**ADDENDUM # 4****Renovation of Commons A**

WBA 21-034.01

**TO: All Bidders****DATE: 30 January 2023**

**Renovation of Commons Building A**  
**BID SET**  
Tuskegee University  
Benjamin F. Payton Drive, Tuskegee, AL 36088  
21-034.01

SHEET NUMBER:  
**A7.6**

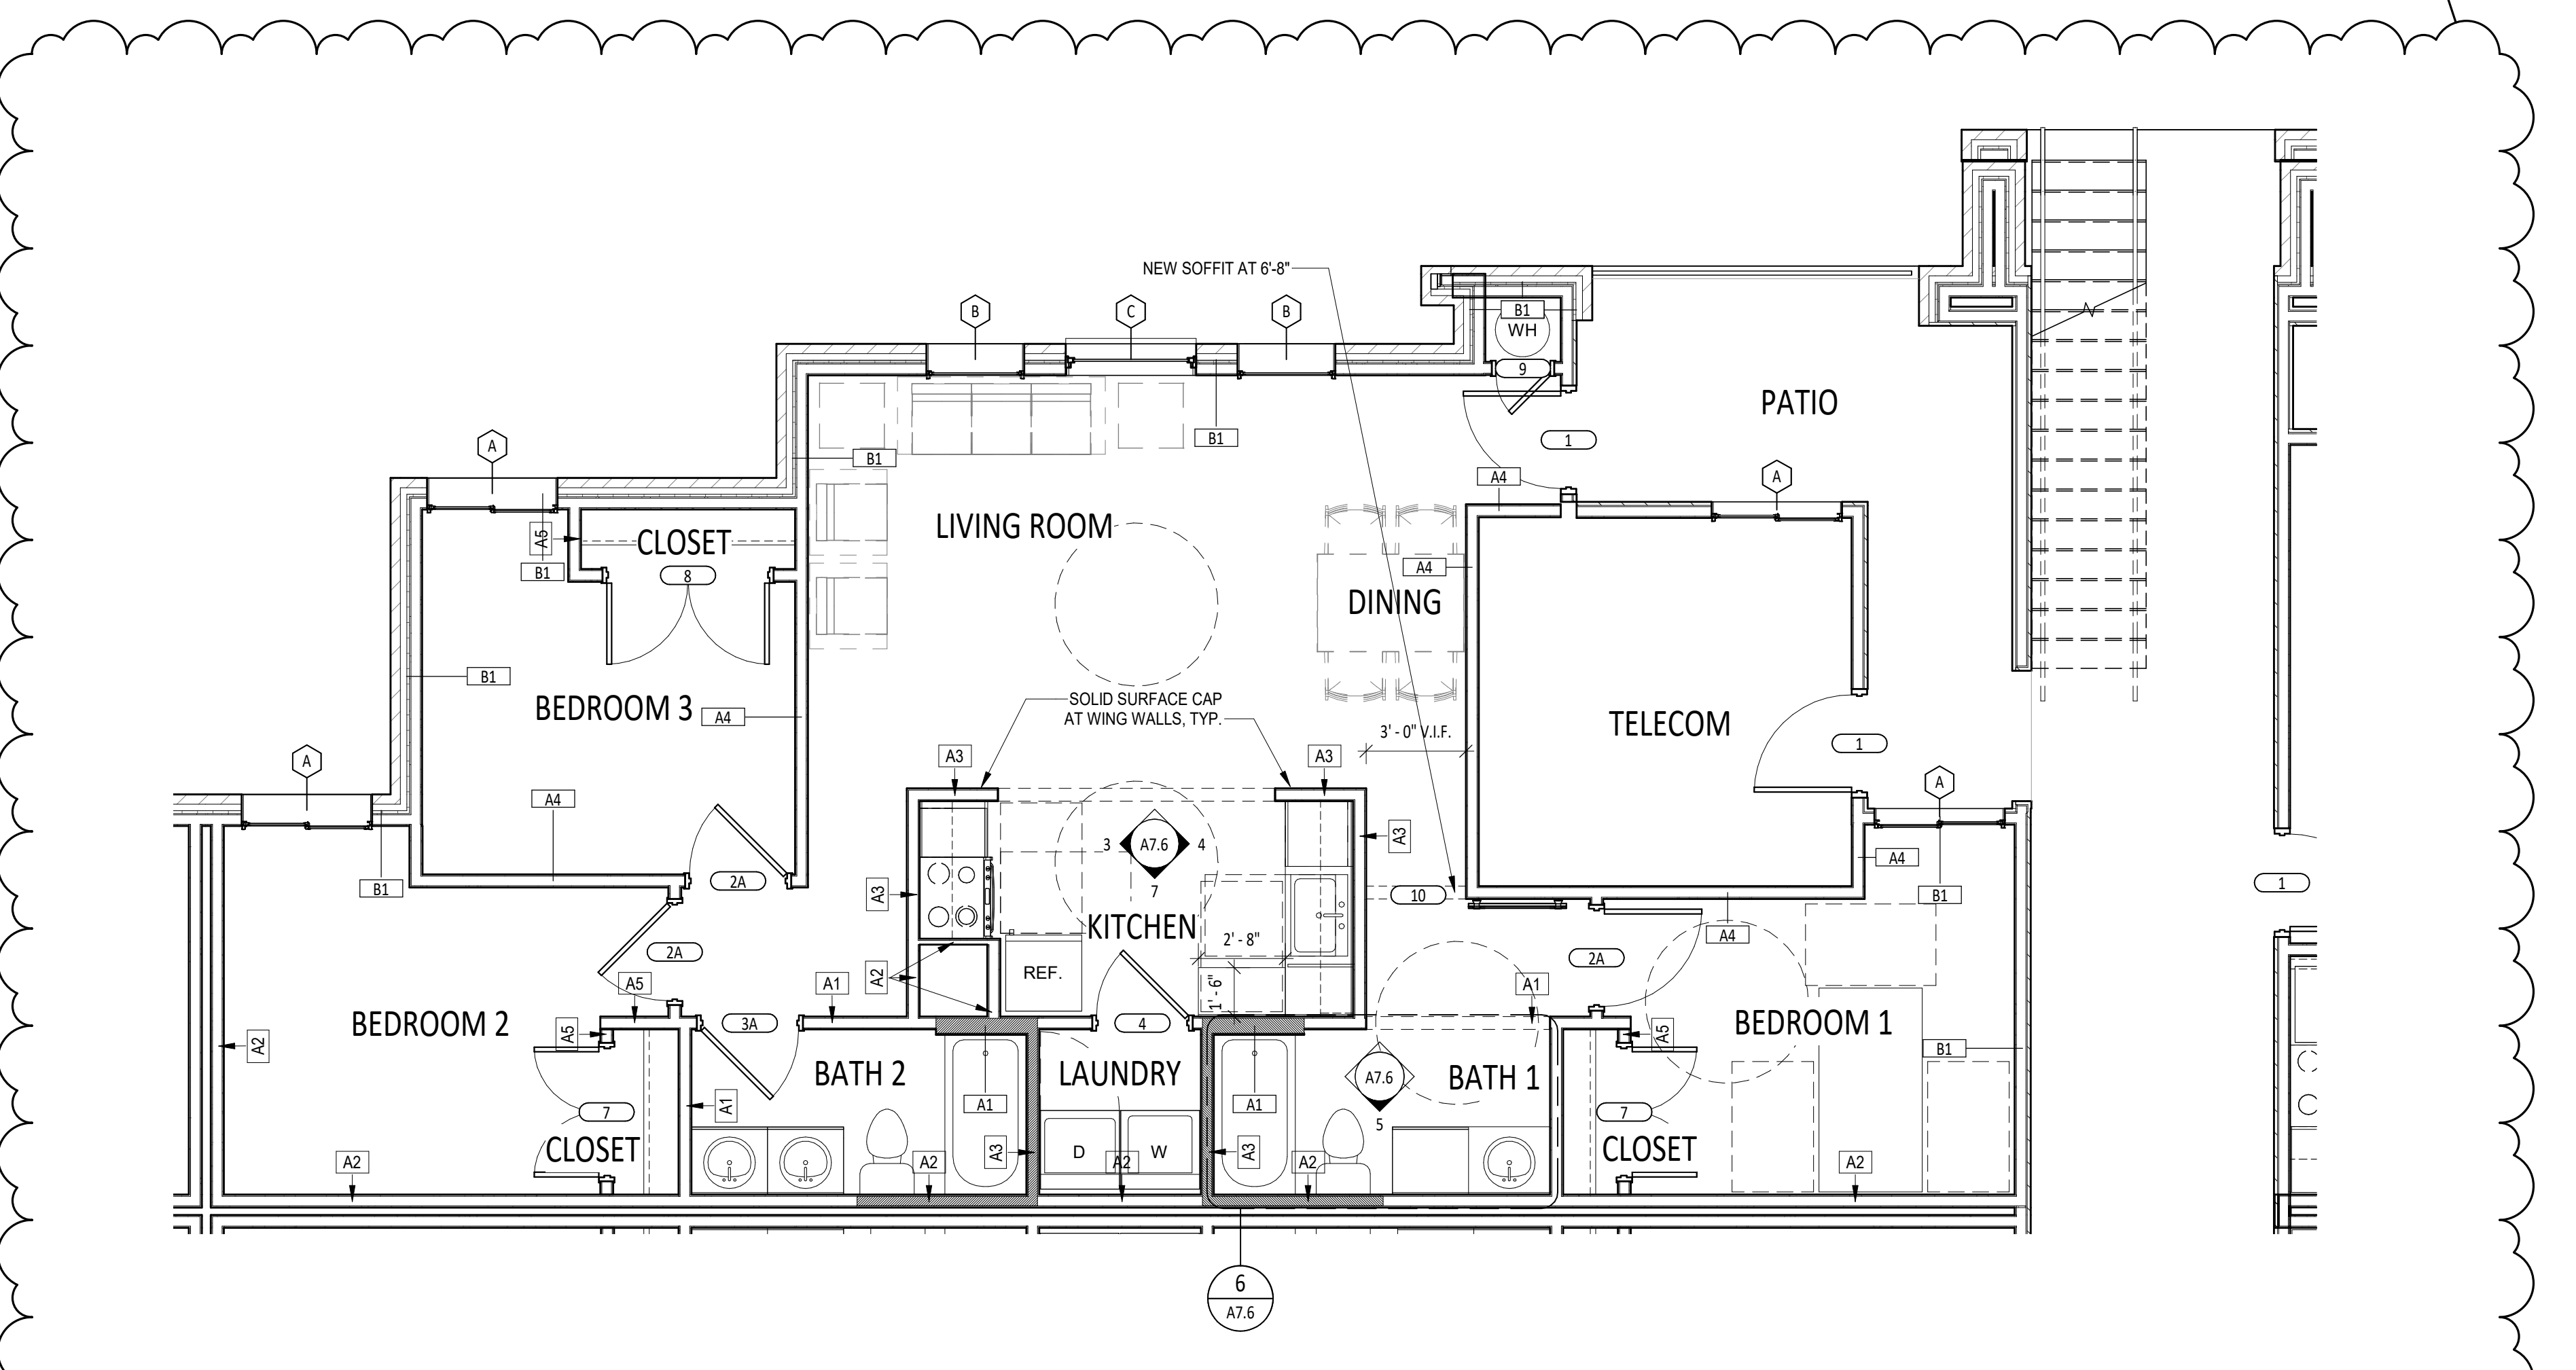
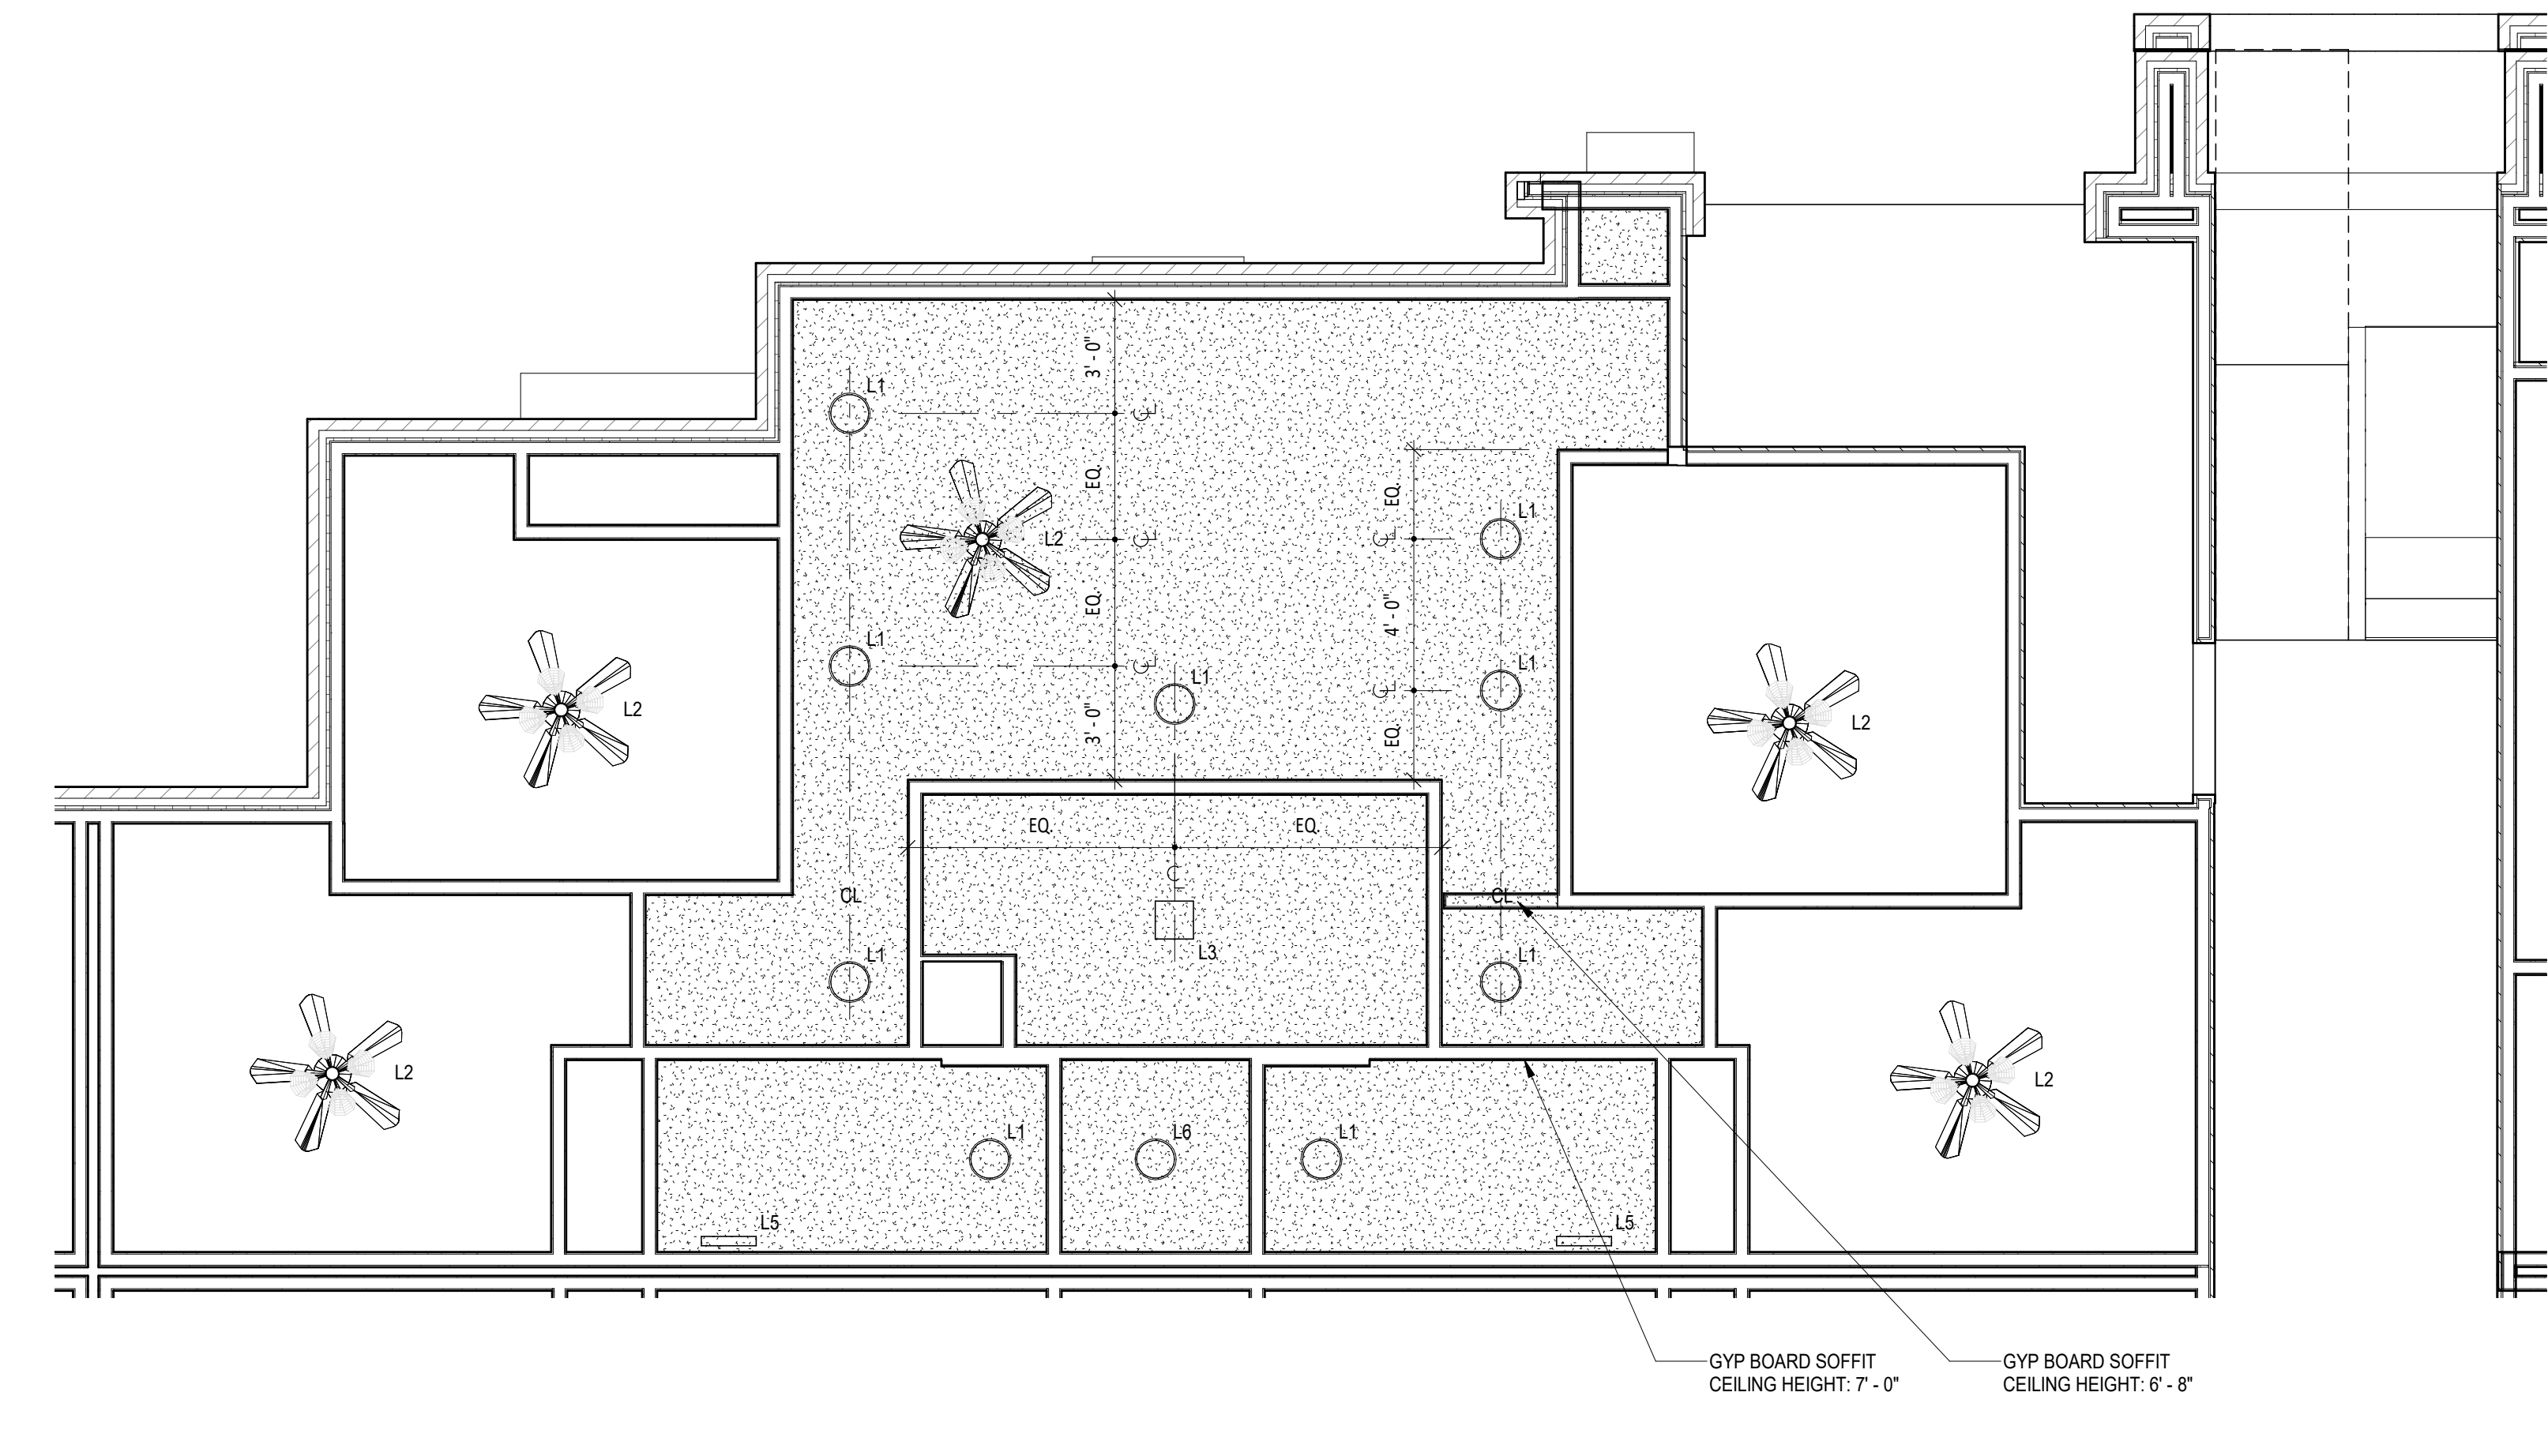
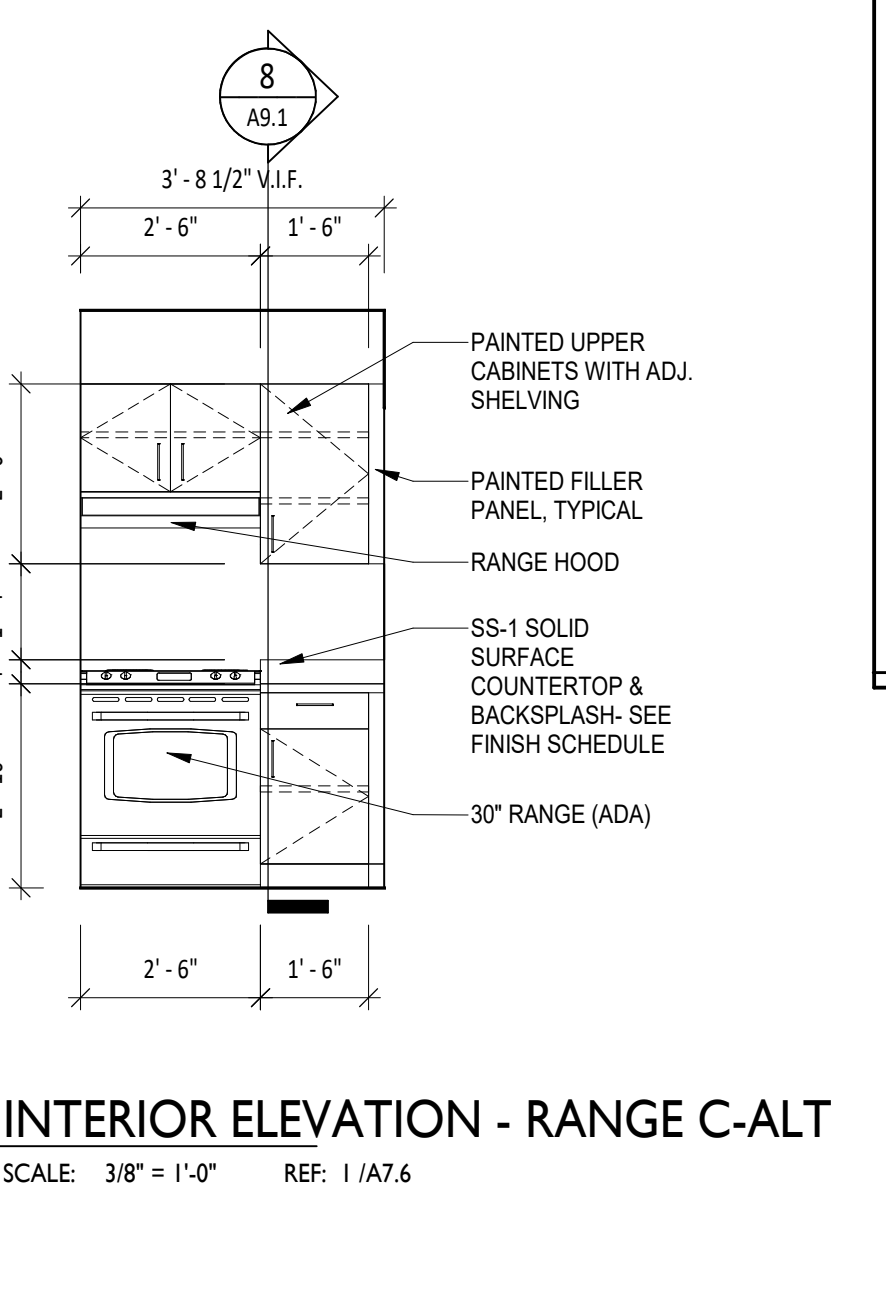
9. Sheet A7.6 – Updated ADA Compliances to incorporate DCM review comments.
